Burlington Design Advisory Board

DESIGN ADVISORY BOARD Tuesday July 27, 2021 3:00 PM REMOTE MEETING

MEMORANDUM

To: The Design Advisory Board
From: Mary O'Neil, AICP, Principal Planner
RE: ZP21-0918CA/CU ZP21-213OG
38 Latham Court
Date: June 22, 2021 **July 27, 2021**

1 PROPOSED SHOP/SITE
1/4" = 1'-0"

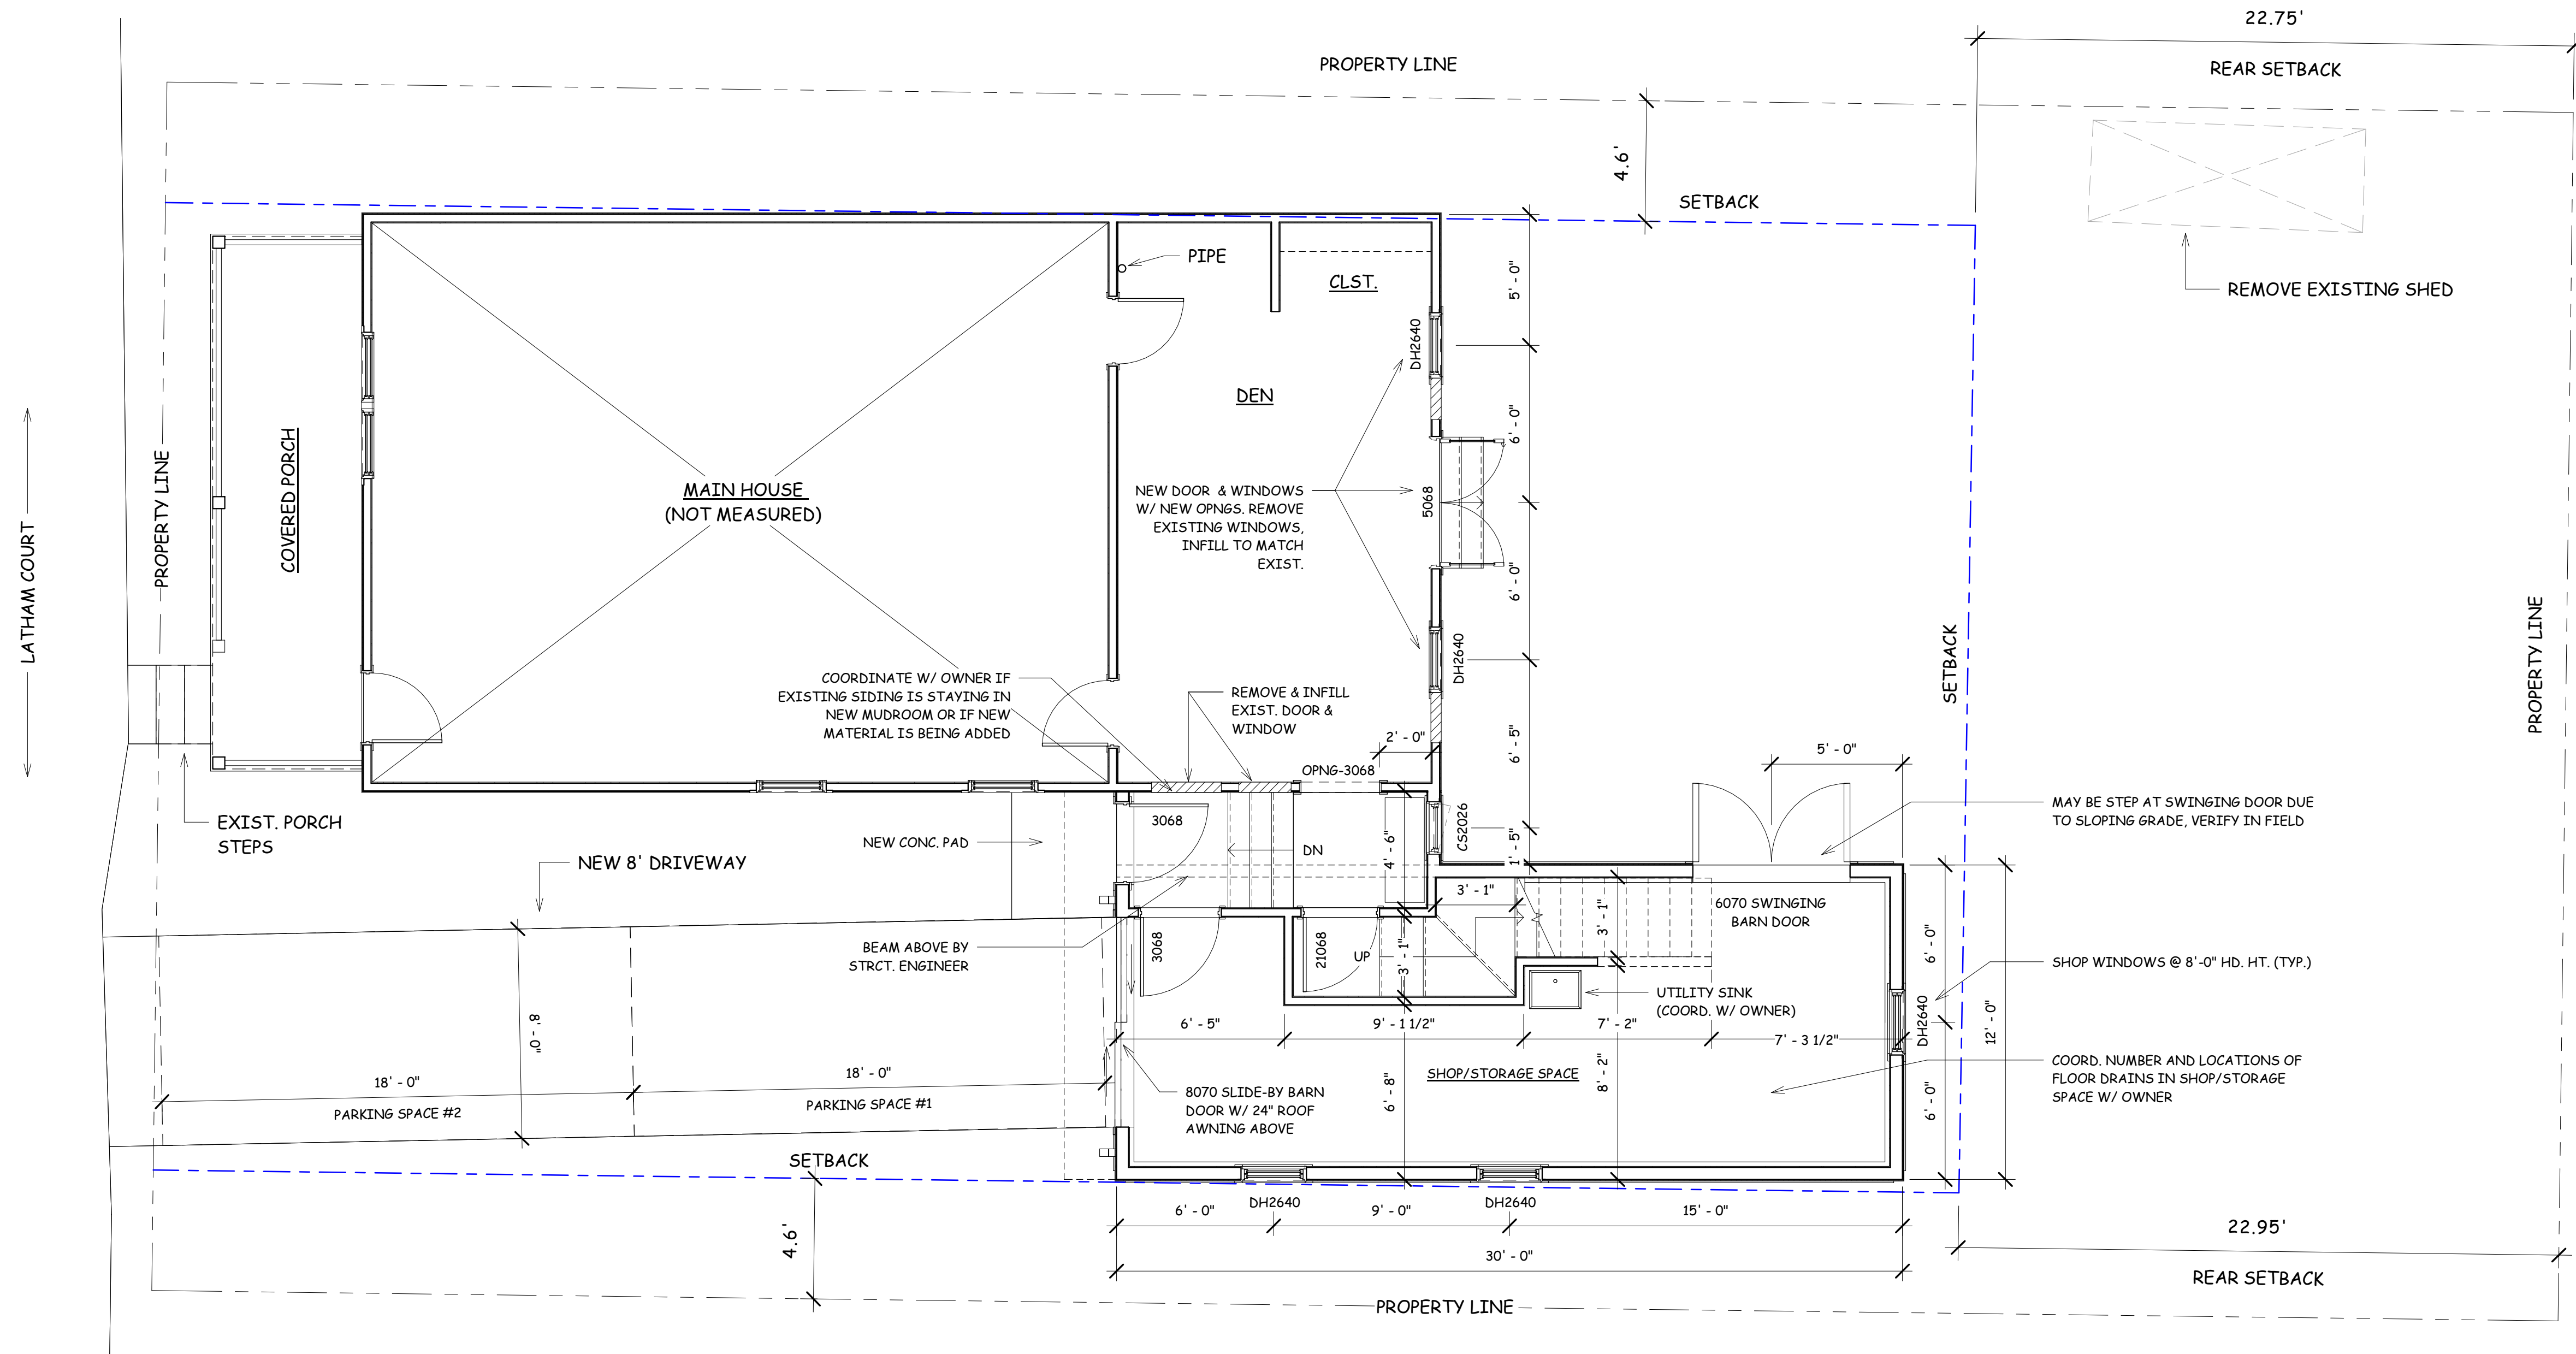
The new entrance to the addition will be under a small pent roof. The newly proposed patio door will be situated under an eaveline, with a modicum of protection from inclement weather.

There is limited room for snow storage north of the driveway unless the garden area may provide such space. South of the driveway has approximately 4'7" that could accommodate snow storage needs.

The roof has been modified to be a full gable and eave structure. The west gable end has been extruded, with decorative brackets below.

The proposed addition has glazing each gable end, with three windows in each eaves side of the structure. The replacement of two double hung windows in the principal structure and the addition of a French door are included. See plan A-2.

SHEET TITLE:
PROPOSED
ELEVATIONS

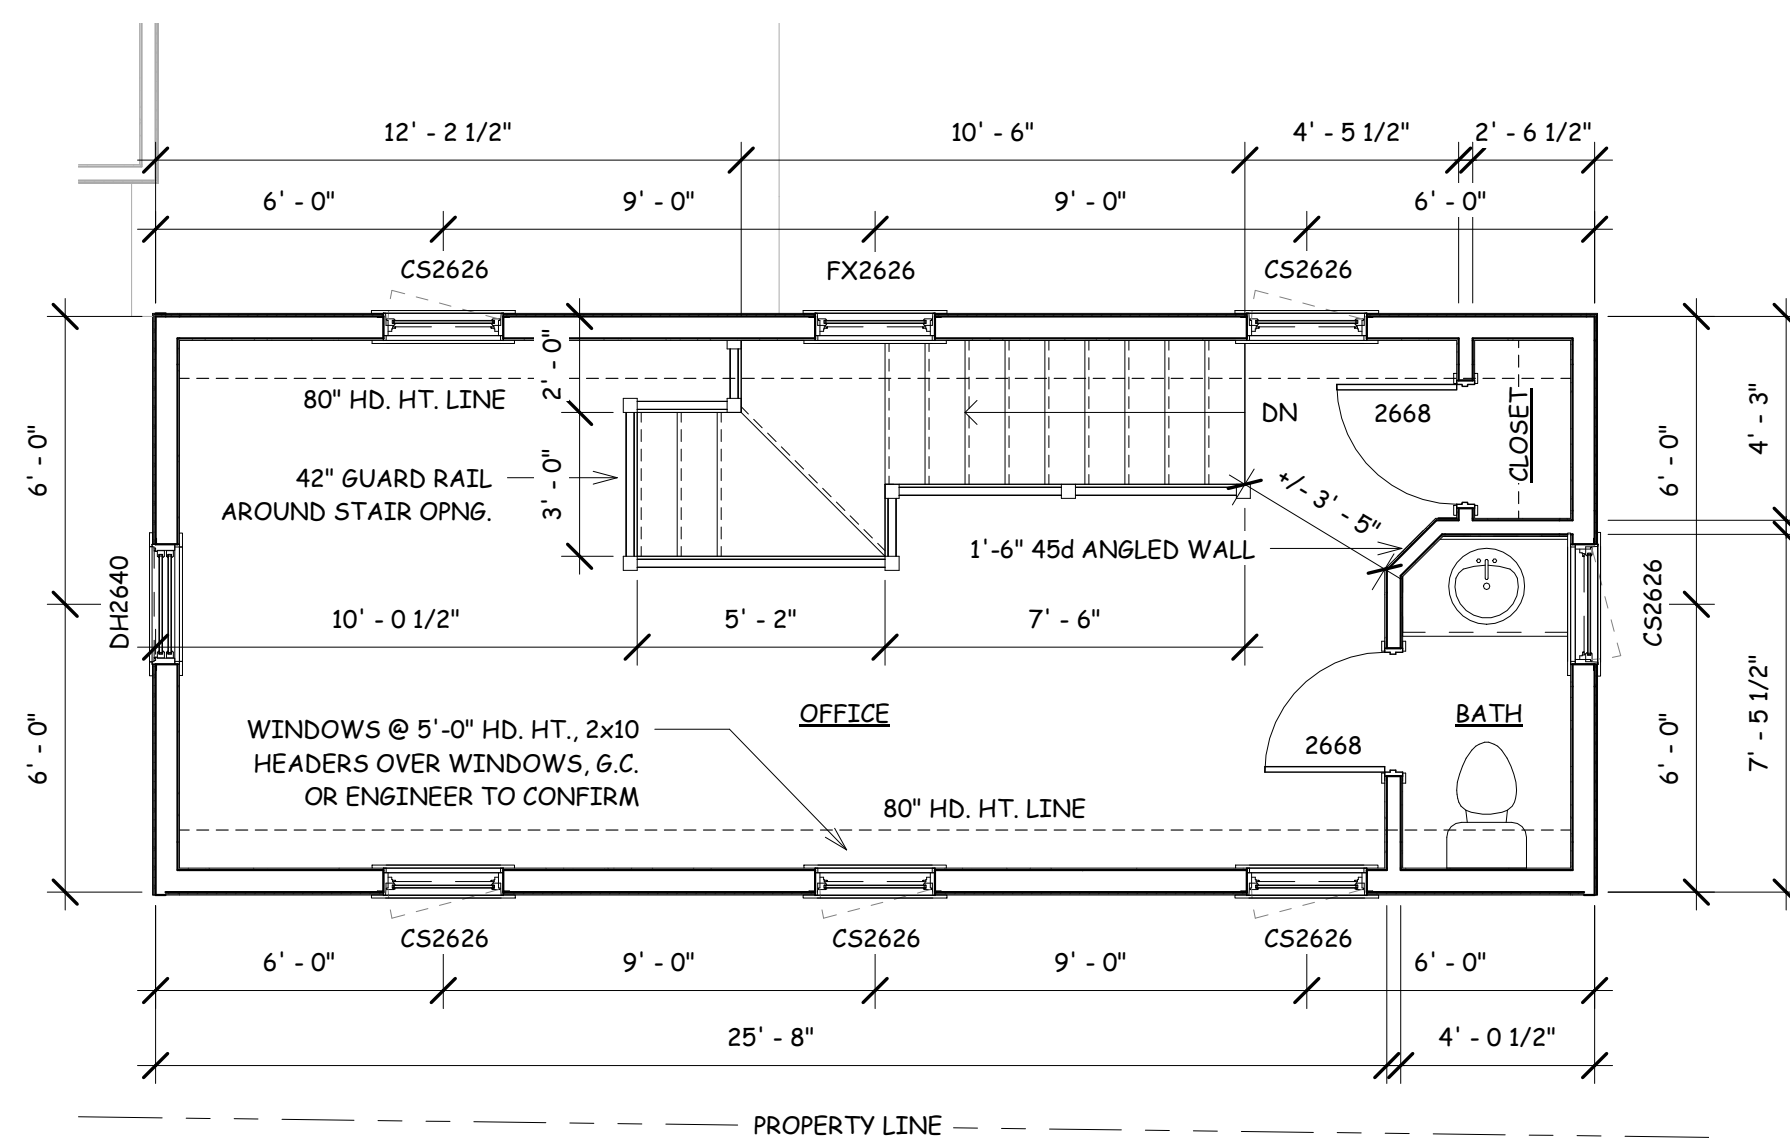
Clapboard siding with shake detail in the gable end, and a standing seam roof are intended for the addition.

Replacement windows are wood core. Window pattern, as illustrated in Plan A-2, represent a mix of 6/1 on the first floor and second floor west gable end, and four-lite window sash on the 2nd floor. Egress may be required from the second floor as it is intended to be habitable space. The applicant/design team shall confer with the building inspector to determine whether the proposed windows will meet life safety requirements.

LEVEL 1 HOUSING

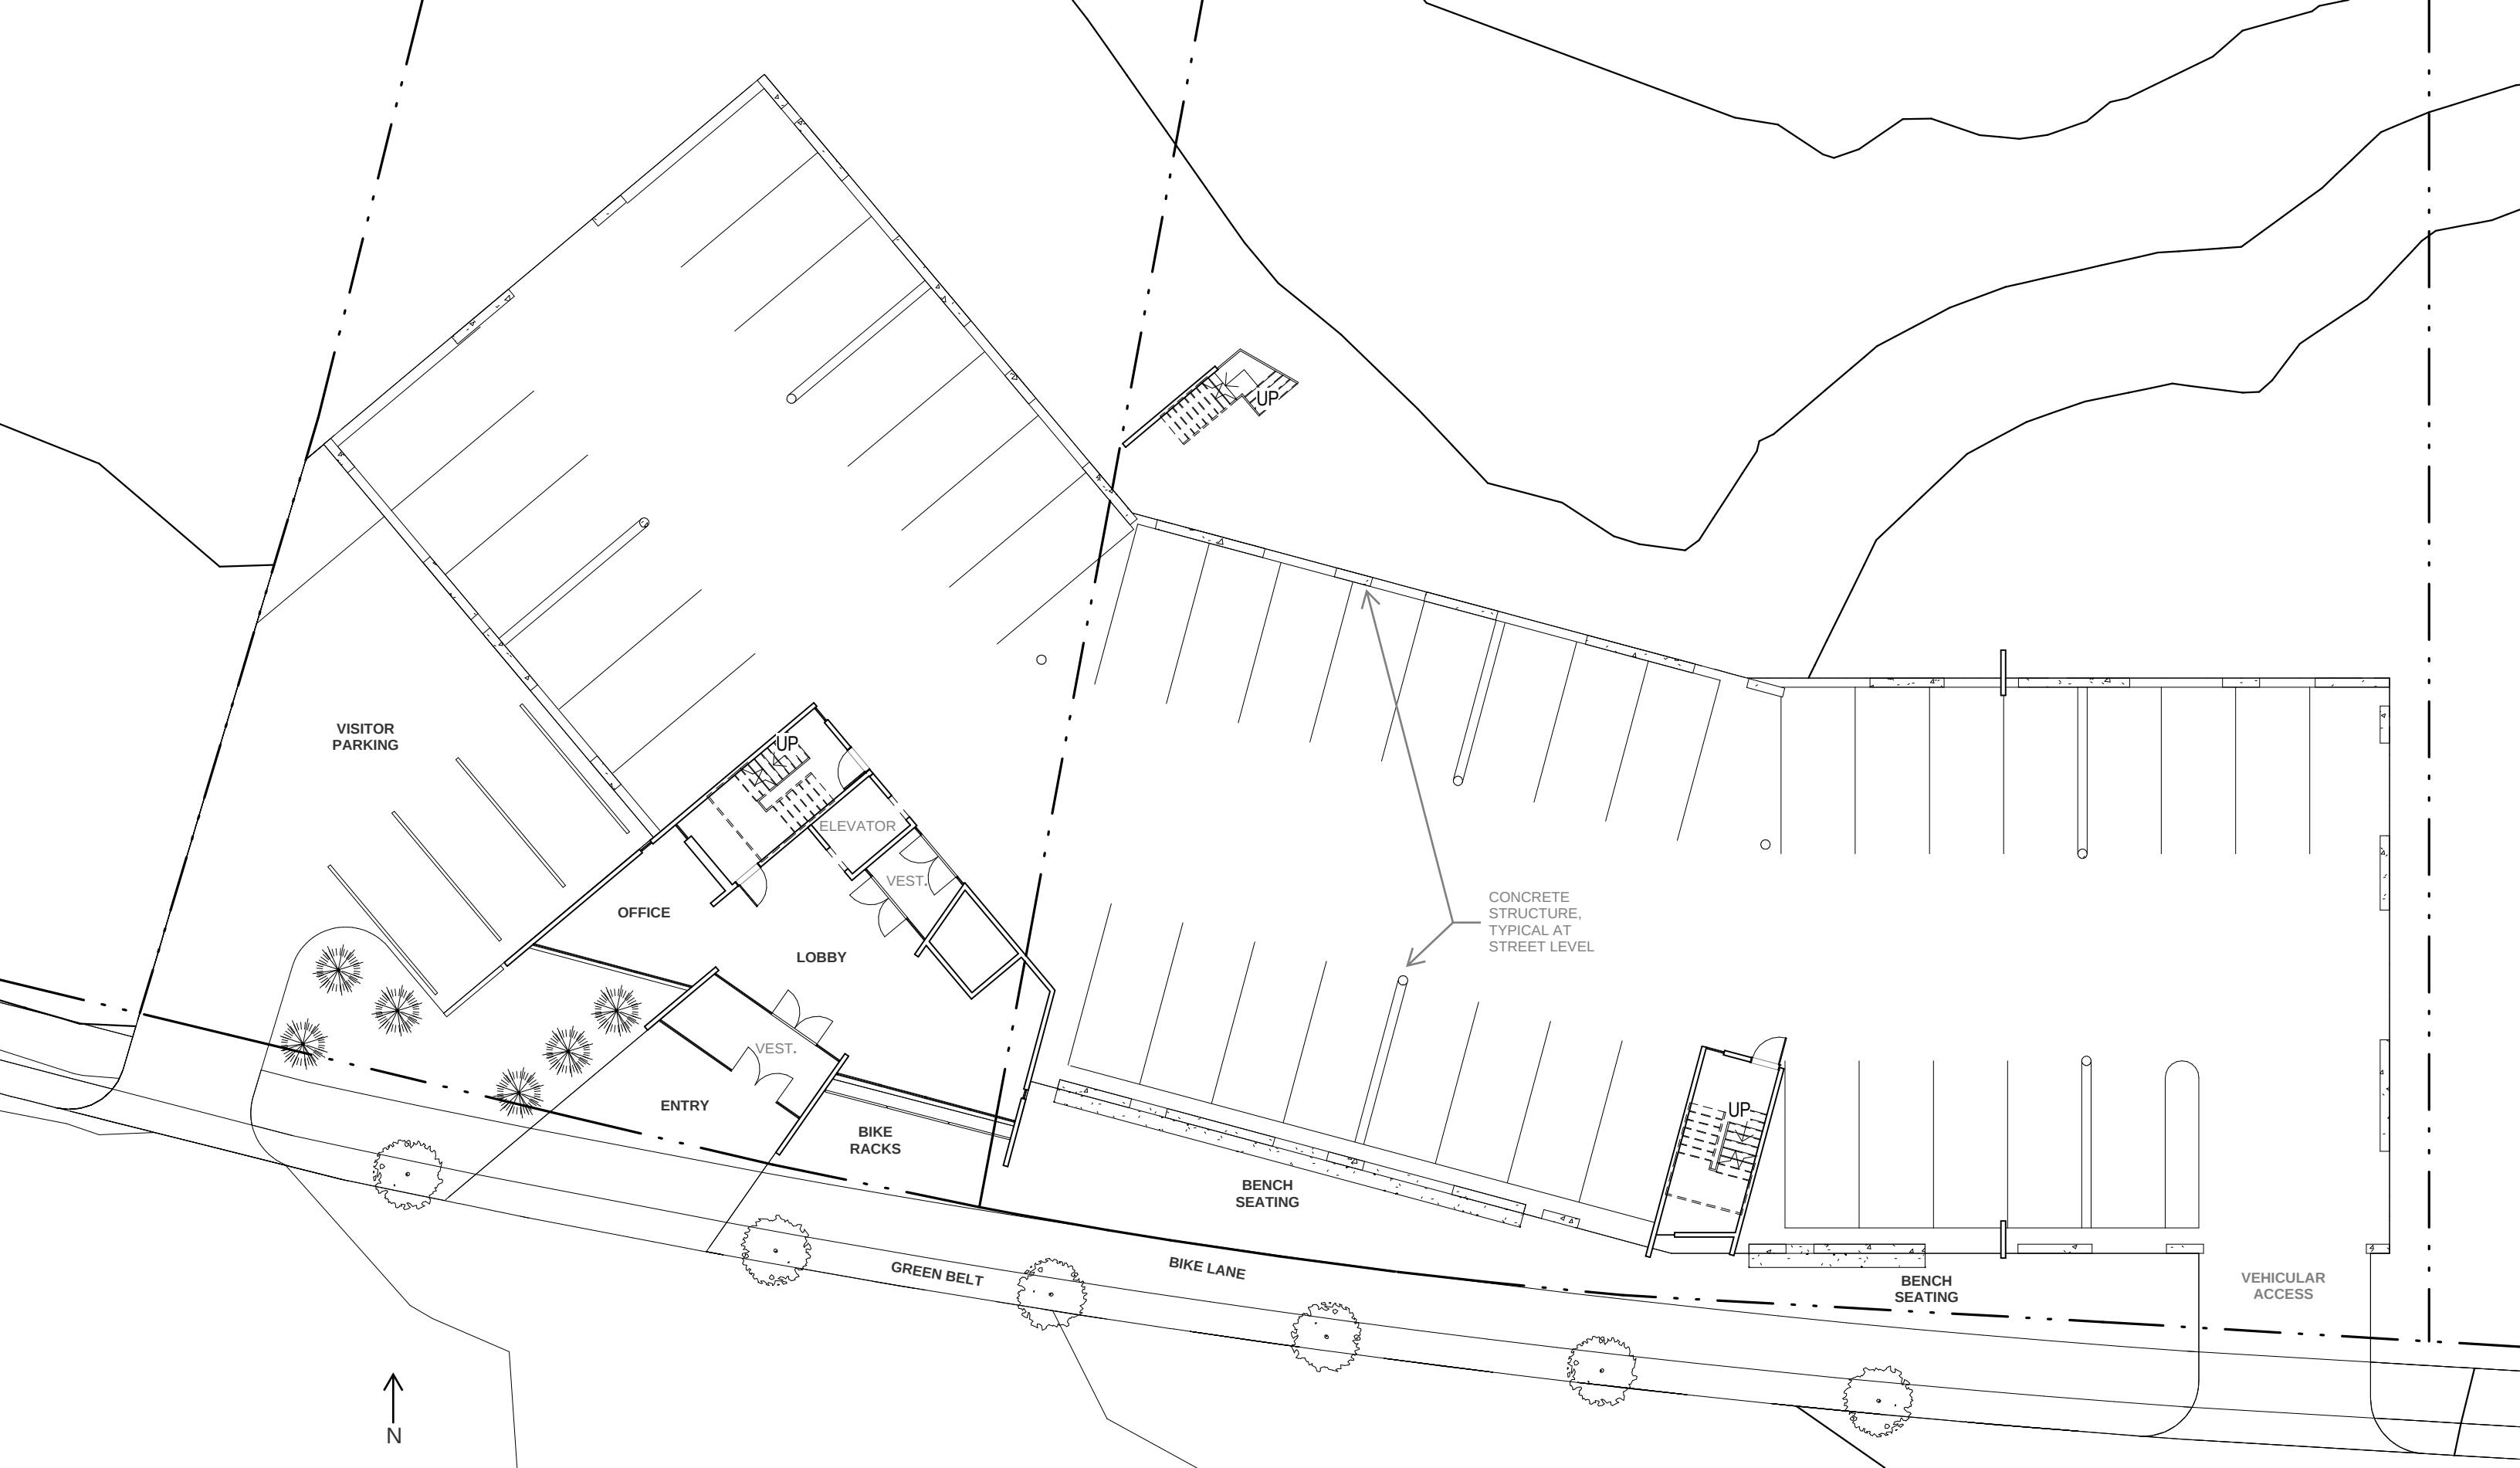
No public plazas or open spaces are proposed. The floor plans depict a stairway down to ground level behind the building. Is this simply emergency egress, or is a more formal access to the wooded portion of the property down to the river contemplated?
